Office Action Summary

10/506,415

This Office action is in answer to the amendment filed 7/17/2006. Claims 5-7, 12-16 are pending, and claim 13 is amended.

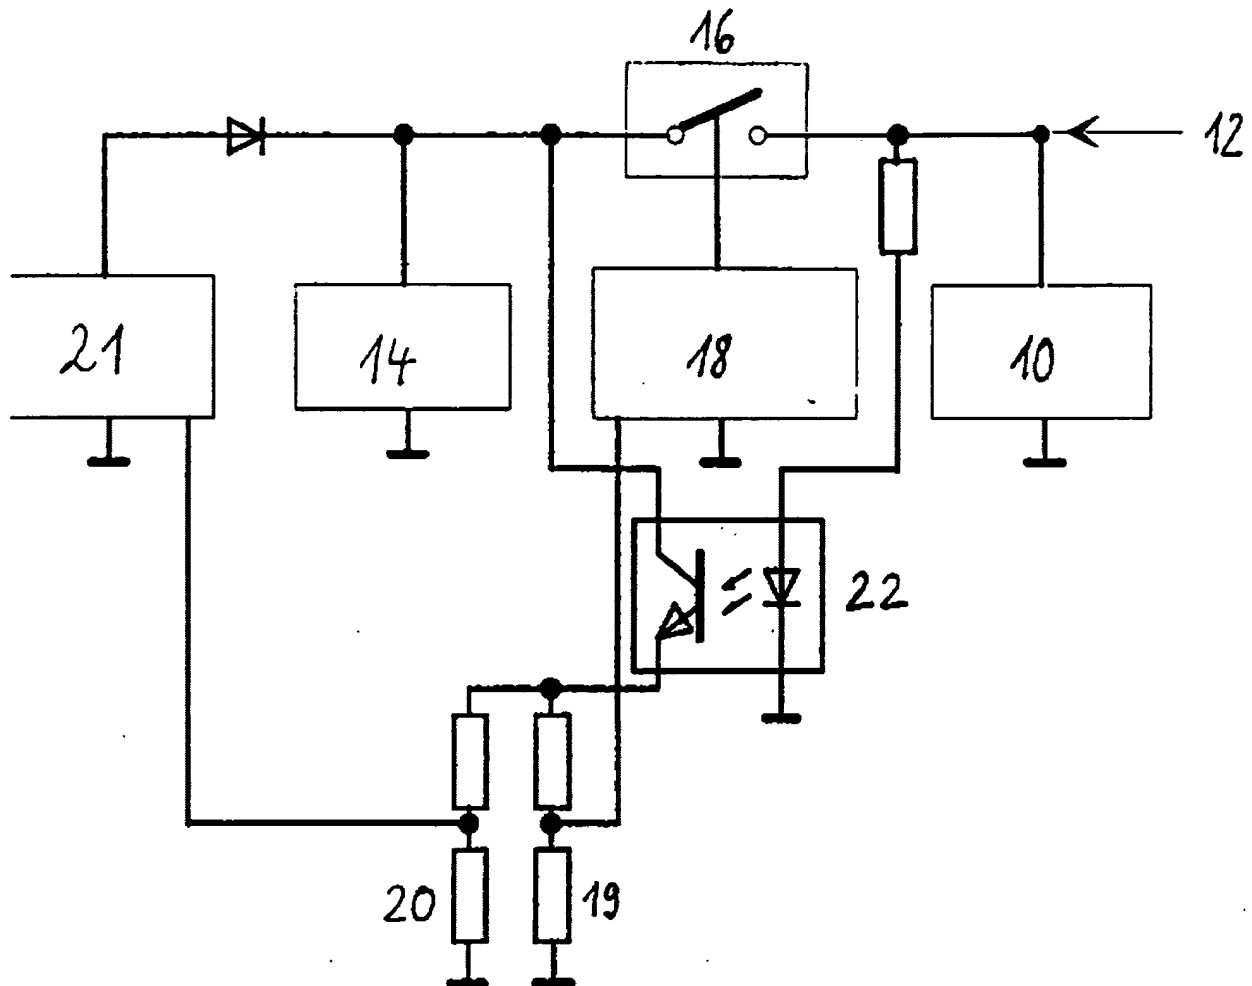
d) DE-19533537 also discloses in the abstract and in the figure:

The circuit protects a battery (14) provided for maintenance of supply to a load (10) after failure of the mains (12), which causes an electronic switch (16) to be closed by voltage monitoring and control logic (18). The deep-discharge measurement circuit and the battery-charging circuit are connected by an opto-coupler (22).

When the monitored voltage approaches the deep discharge limit, the switch is reopened and the load disconnected from the battery. The measuring and charging circuit voltage sensors (19,20) with the charge regulator (21) are also electrically isolated to prevent reconnection of the battery, which can occur only when the mains voltage is restored.

**FIGURE 5**

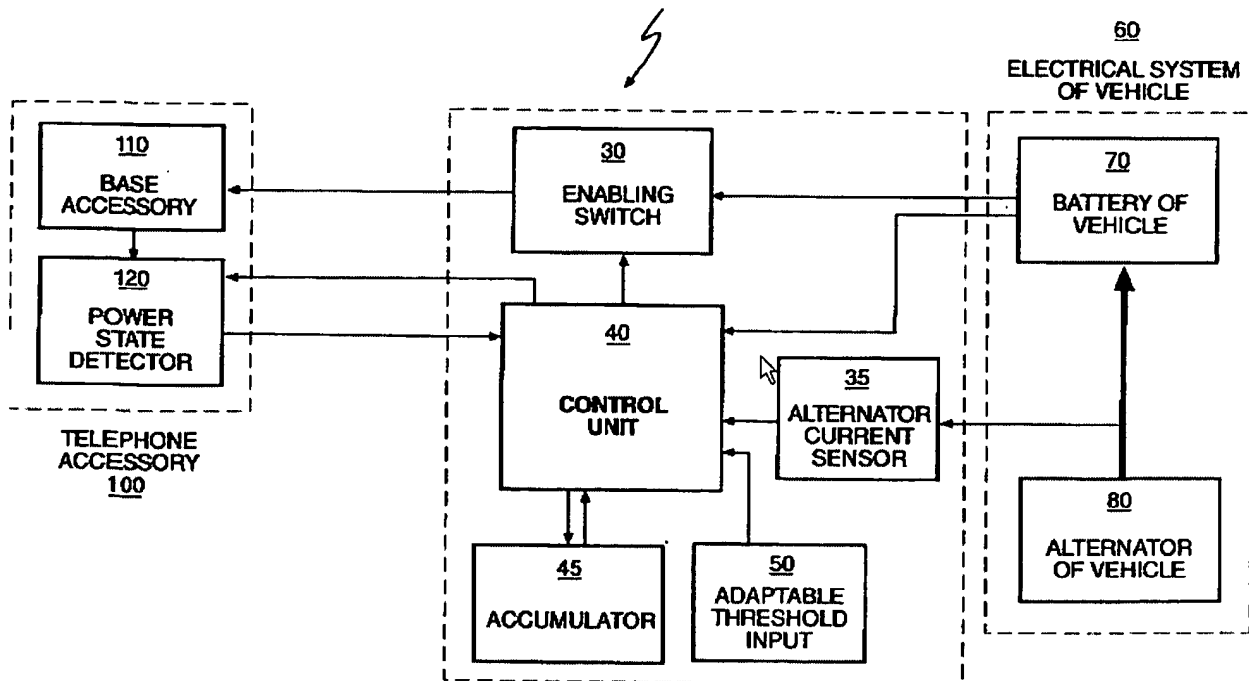
Irvin [5929604] discloses a battery-discharge-protection system for electronic accessories used in vehicles containing a battery so that when the total energy consumption meets or exceeds a threshold, the power to the battery-powered telephone device is interrupted in order to conserve a sufficient amount of power to start the vehicle and to operate other peripheral systems. This system includes an **"enabling switch"**:

FIG.3

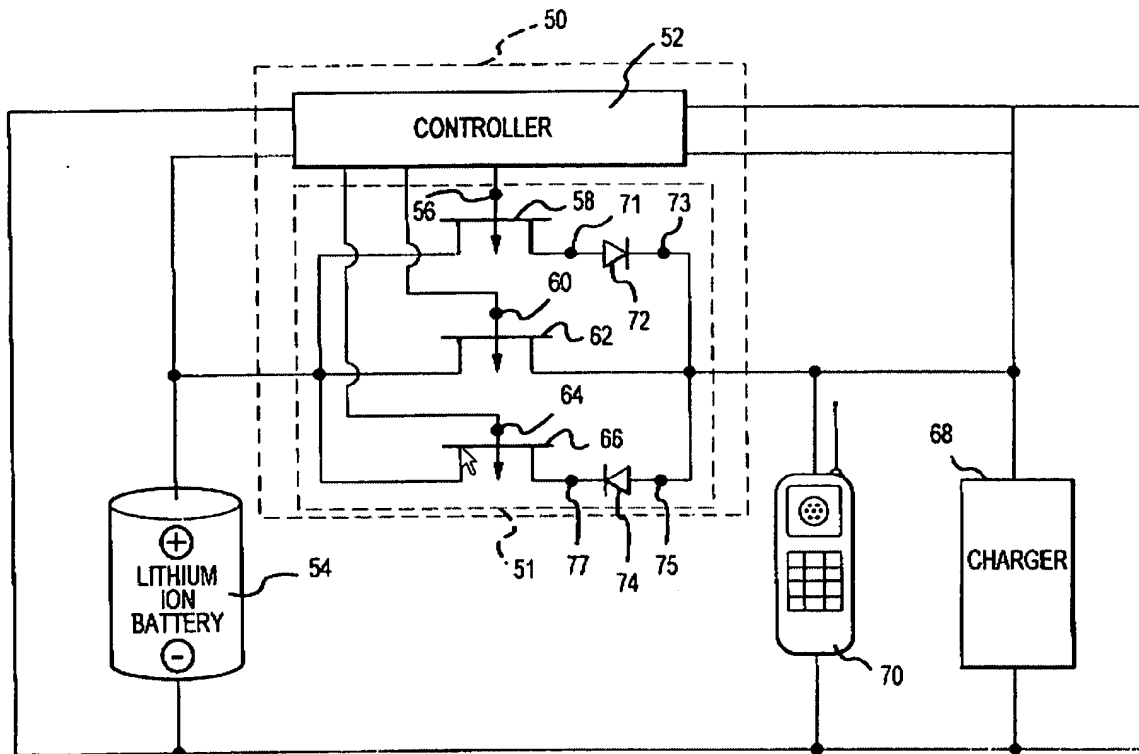
Colles et al. [5949218] discloses an apparatus for regulating the voltage potential of a lithium ion battery based upon an operating range having an upper threshold (e.g., on the order of 4.2 v) and a lower threshold (e.g., on the order of 2.5 v) and for providing a reduction in dissipated power when the lithium ion battery is charging and when a load is drawing upon the lithium ion battery:

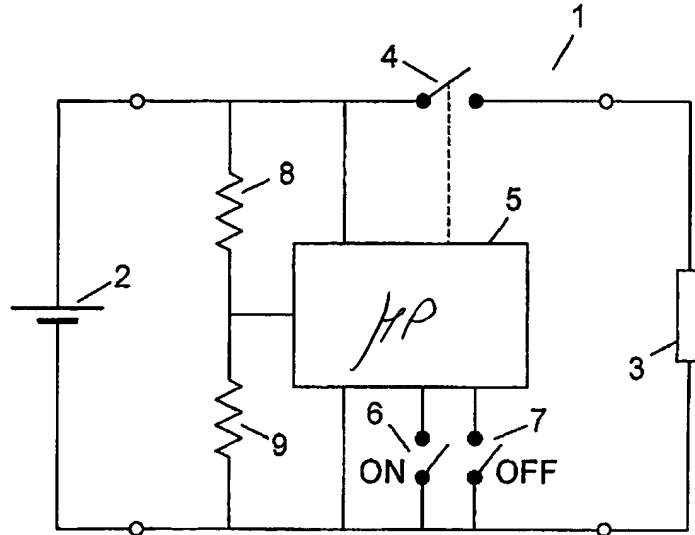
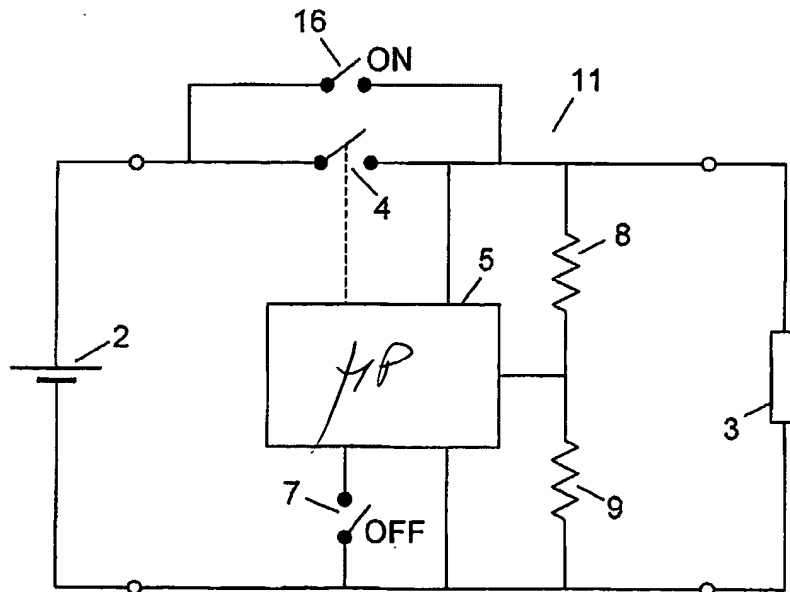
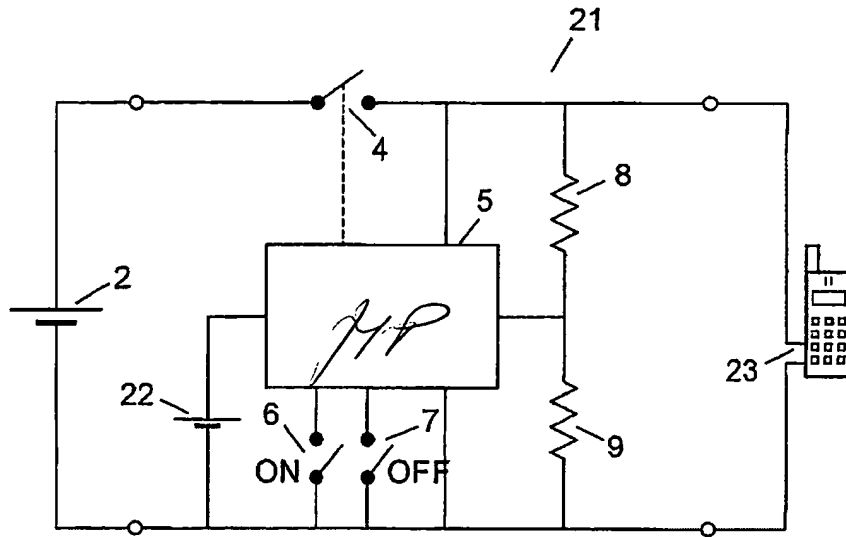
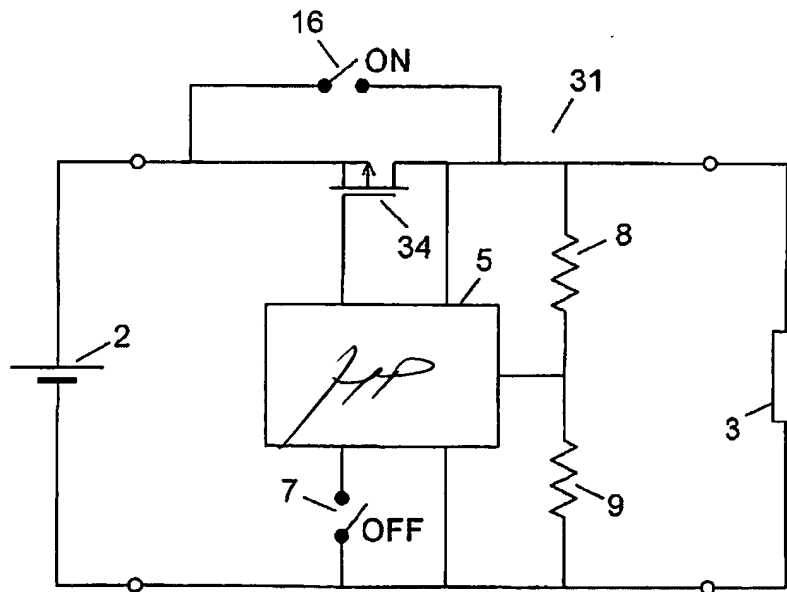
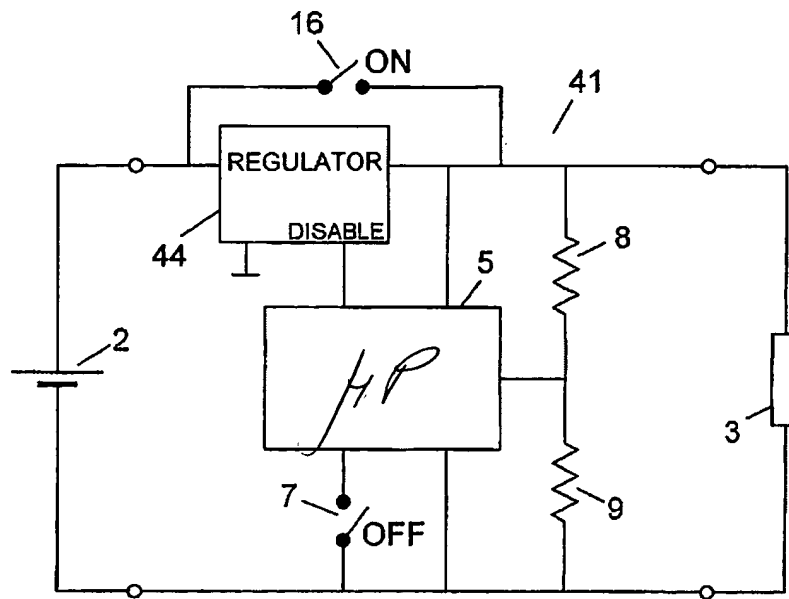
1. The drawings are objected to under 37 CFR 1.83(a). The drawings must show every feature of the invention specified in the claims. Therefore, the **microcontroller**, the **microprocessor** must be shown or the feature(s) canceled from the claim(s), as per attached. No new matter should be entered. Corrected drawing sheets in compliance with 37 CFR 1.121(d) are required in reply to the Office action to avoid abandonment of the application. Any amended replacement-drawing sheet should include all of the figures appearing on the immediate prior version of the sheet, even if only one figure is being amended. The figure or figure number of an amended drawing should not be labeled as "amended." If a drawing figure is to be canceled, the appropriate figure must be removed from the replacement sheet, and where necessary, the remaining figures must be renumbered and appropriate changes made to the brief description of the several views of the drawings for consistency. Additional replacement sheets may be necessary to show the renumbering of the remaining figures. Each drawing sheet submitted after the filing date of an application must be labeled in the top margin as either "Replacement Sheet" or "New Sheet" pursuant to 37 CFR 1.121(d). If the examiner does not accept the changes, the applicant will be notified and informed of any required corrective action in the next Office action. The objection to the drawings will not be held in abeyance.

a) 37 CFR 1.83(a) requires drawings to show the conventional names, as described in the specification, e.g. microprocessor, etc. for the elements shown in figures with non-conventional symbols.

APPROVED AS REVISED
9/10/06 DAB

APPROVED AS REVISED
9/10/06 PB

Approved as Revised
9/16/06
